NHTSA SAFETY RECALL

EHC CONTACT IMPROVEMENT - Recall #10X-XXX

IDENTIFICATION: Applies to all 2004 Motorcycles for which Service Bulletin SB1078 has not been performed, or EHC Adapter Board Kit 173-000037-00 has not been installed.

Figure 1

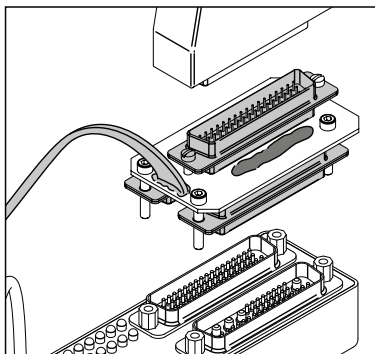
NOTE: It is not necessary to perform this recall procedure if Service Bulletin SB1078 has already been performed, or if EHC Adaptor Board Kit 173-000037-00 has been installed on the motorcycle (dielectric grease already included in connectors) (see Figure 1).

Figure 2 - Peel rubber gasket from EHC carefully, lifting gasket vertically.

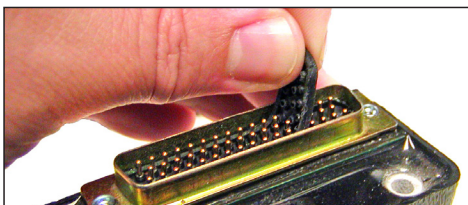
1. Disconnect the black, negative (-) battery cable.
2. Disconnect the harness connector from the EHC.
3. Remove the rubber gasket from the harness connector port (see Figure 2) and discard.

CAUTION: REMOVE RUBBER GASKET FROM HARNESS CONNECTOR PORT BY LIFTING VERTICALLY FROM PORT TO PREVENT DAMAGE TO CONTACT PINS (FIGURE 2). **DO NOT** REMOVE RUBBER SEAL BY PULLING THE SEAL BACK ON ITSELF (FIGURE 3).
